CORRECTED SURREBUTTAL TESTIMONY

CLAIRE M. EUBANKS, P.E.

AMEREN TRANSMISSION COMPANY OF ILLINOIS

CASE NO. EA-2024-0302

Case No. EA-2024-0302
Schedule CME-s2
Page 6 of 10

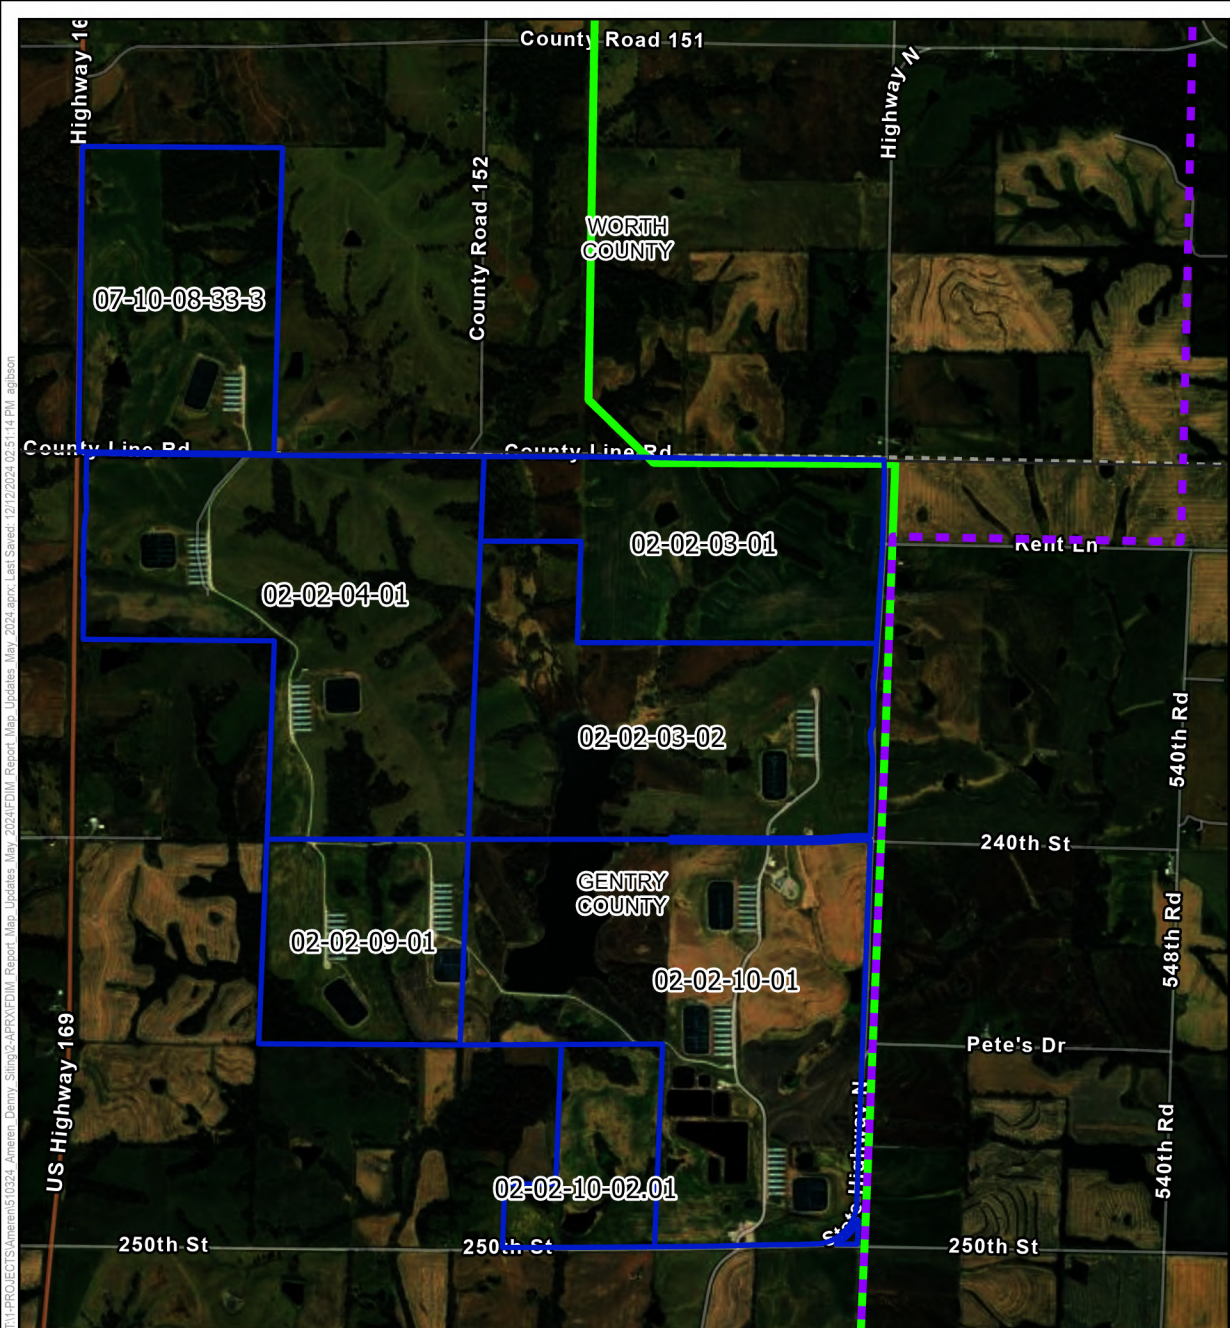
Regarding the hog-farm discussed at page 29 of TRC's FDIM routing study and page 21 of James Nicholas' direct testimony. 1. TRC and James Nicholas indicates the hog farm facility is located southeast of the intersection of Highway N and 230th road. Please confirm that the hog farm is located to the southwest of the intersection of Highway N and 230th road. 2. Please identify all parcels associated with the hog farm facility.

1. The hog farm facility is located to the southwest of the intersection of Highway N and 230th Road.
2. Please see MPSC 12.1 Attach.
